**WORKSHOP WITH PLANT WALKDOWN IN  
TEMELIN, UNDER THE CZECH-AUSTRIAN  
BILATERAL AGREEMENT  
SEPTEMBER 26/27, 2006**

Report – Final Version

December 29, 2006

**Fig. 1.1:** Main steam lines with steam generators, bubliks and valves (presentation “Improvement in A820 Compartment”, see Appendix 1 for full reference)

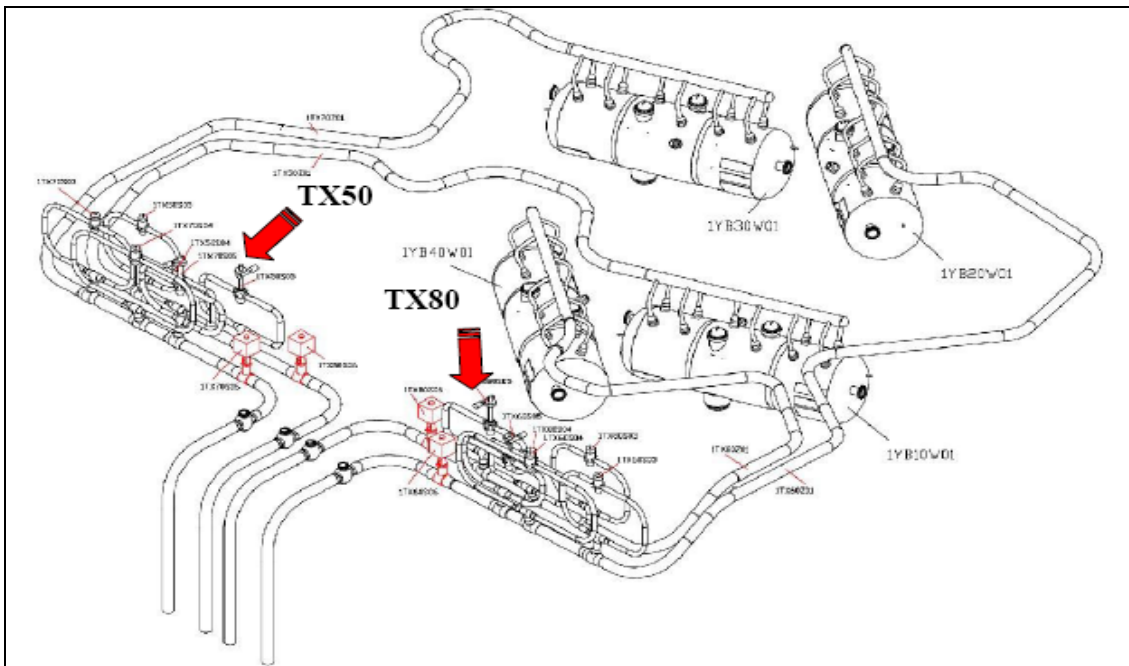
The **SUPERPIPE Concept application** is not supposed to be extended to the bubliks' areas. (Bubliks are piping loops connected to the main steam lines, each with a T-joint and a T-valve.) Conceptual improvement measures and their implementation are likely to render the situation there more acceptable. The basic Czech approach was to declare the main secondary steam lines and the main secondary water lines to be no break zones, manufactured according to modified USNRC and French requirements and endorsed by the required analyses and stepped-up ISI. This approach was said to have been reviewed by NRC experts in the field. Their statement was that the physical lay-out could be accepted. The NRC review's results, however, were not discussed nor provided. They would have been helpful for a better understanding of the issue.

The bubliks remain a postulated break zone. Regarding the **selection of break locations**, the revised pipe support/suspension concept was applied to the bubliks with GERB dampers (supplied by GERB Vibration Control Systems, an international group of companies) at distinguished locations. The consideration to reduce maximum load combinations led to the limitation of motion, acceleration, frequencies and resonance of the pipe sections there. The investigations into the vibration properties of the bubliks indicate that it is difficult to demonstrate that breaks at the "critical" break locations will not be initiated by maximum load cases. This demonstration would require confirming that stresses and strains would remain within allowable limitations. Besides this, it must be demonstrated for the break events assumed to occur that they have negligible secondary effects in the area in question.

**Fig. 2.1:** Preliminary results of RPV Temelin 1 + 2 (presentation “Surveillance Programme”, see Appendix 1 for full reference)

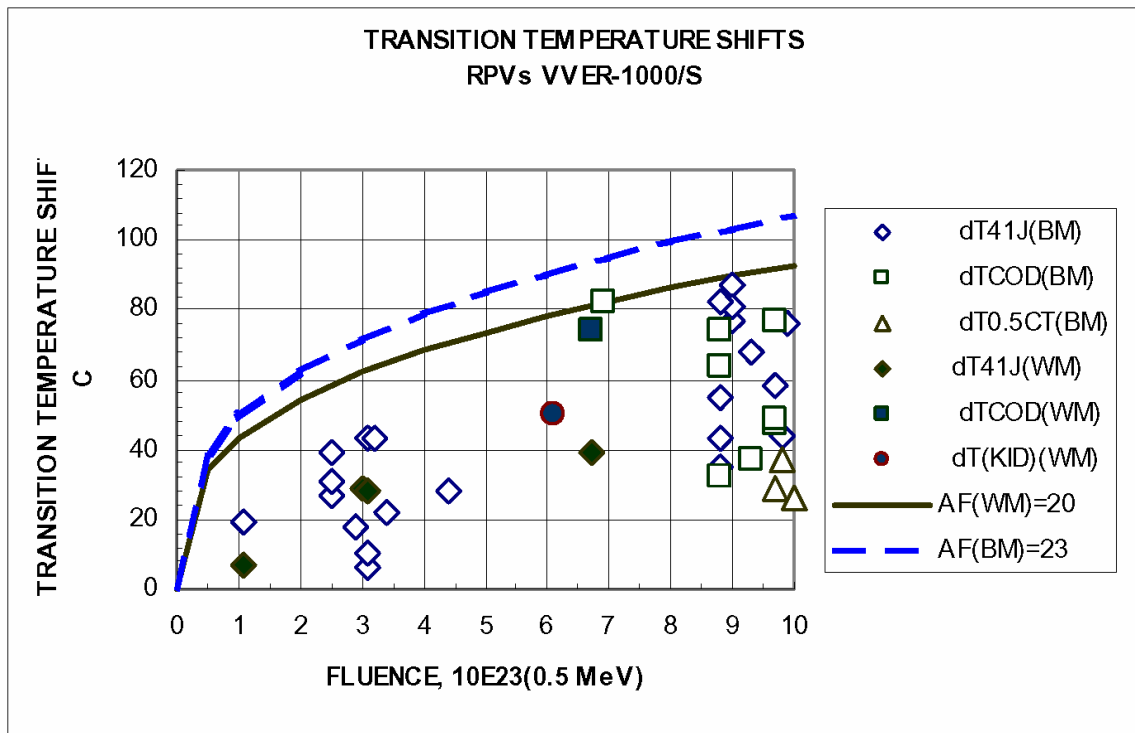
The Austrian team of experts recommends to gain access to information on the embrittlement development sufficiently detailed for evaluation. The notification about material properties as determined experimentally in the surveillance programme is of high importance in order to verify the compliance of material properties to the code specifications.

**Fig. 7.1:** Fuel failure history at Unit 2 developing over 3 campaigns, compared to WANO qualification criterion (presentation, see Appendix 1 for full reference)

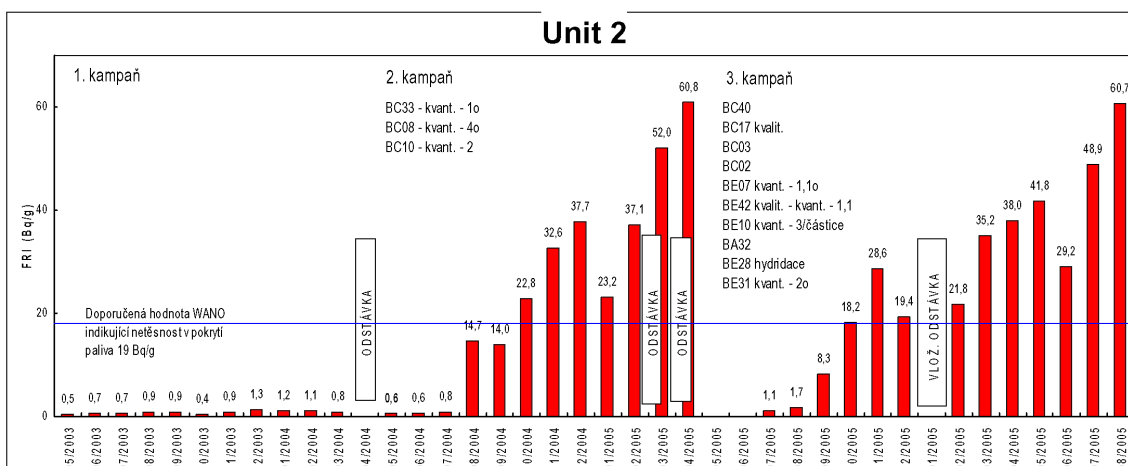
It can be seen from Fig. 7.1 that the number of leaky assemblies, identified and removed from the core during refuelling, is increasing with the number of fuel cycles.
